SUBJECT: CALLAWAY PLANT, UNIT 1 – SAFETY EVALUATION REGARDING
IMPLEMENTATION OF MITIGATING STRATEGIES AND RELIABLE SPENT
FUEL POOL INSTRUMENTATION RELATED TO ORDERS EA-12-049 AND
EA-12-051 (CAC NOS. MF0772, AND MF0773)

Enclosure:
Safety Evaluation

CALLAWAY PLANT, UNIT 1

Figure 1 - Callaway SFP Levels of Monitoring

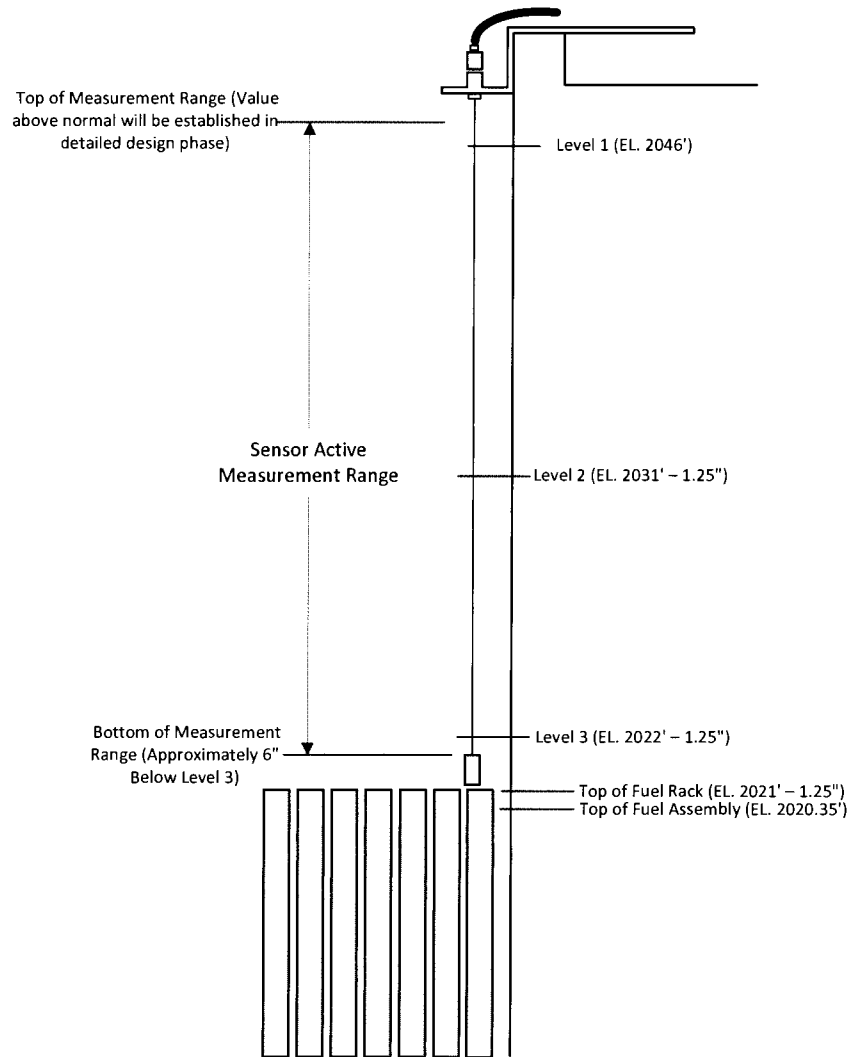
- Level 1 is at the plant elevation of 2046 feet (24 feet, 10.75 inches above the top of the fuel racks).
- Level 2 is at the plant elevation of 2031 feet, 1.25 inches (10 feet (+/- 1 foot) above the top of the fuel storage racks).
- Level 3 is at the plant elevation of 2022 feet, 1.25 inches (1 foot above the top of the fuel storage racks).

In its compliance letter dated July 6, 2016 [Reference 35], the licensee further provided the basis for the designated Level 1 as follows: Calculation M-EC-48, "Minimum Safety Limit for LSL 57 & 58," Revision 0, concludes that the SFP water elevation that is sufficient for the pump's required NPSH [Net Positive Suction Head] is elevation 2043' 6". Level 1 indication is at the normal SFP water operating level of elevation 2046' 0". This confirms that Level 1 has sufficiently covered the calculated level to maintain the pump's required NPSH. In the same letter, the licensee also provided a sketch depicting Levels 1, 2, and 3 and SFP level measurement range as shown in the figure below (Figure 1 - Callaway SFP Levels of Monitoring).

The NRC staff found the licensee selection of the SFP measurement levels adequate based on the following:
